IMPORTANT SAFETY RECALL

NHTSA Recall # 24V-566

Tiffin Recall # TIF-141

PowerGlide IFM Controller Harness Update

**IFM Chassis Controller
needs repair**

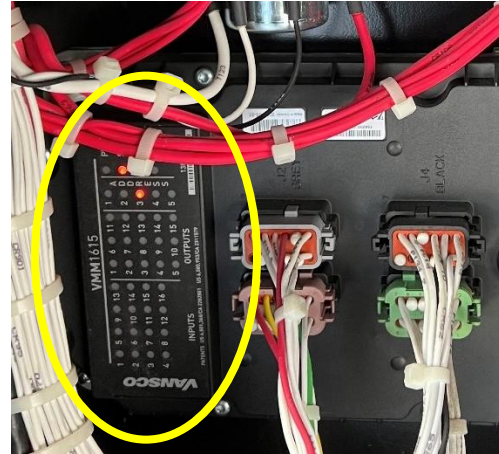
Owners may visually inspect their motorhome to verify their involvement in this recall. During this time frame, Tiffin Motorhomes used different chassis controllers. The chassis controller is in the passenger side rear compartment. After visually inspecting the chassis controller, if it is **not** an IFM brand, **then repair is not required**. Please email recalls@tiffinmotorhomes.com the brand of chassis controller that is installed in your motorhome, along with your VIN number, and we will clear the recall from your motorhome.

Tiffin Motorhomes will have the brand of controller verified and, if an IFM brand of chassis controller is installed, a harness equipped with an inline fuse will be installed to protect the power to the ignition switch in the event of an overcurrent situation.
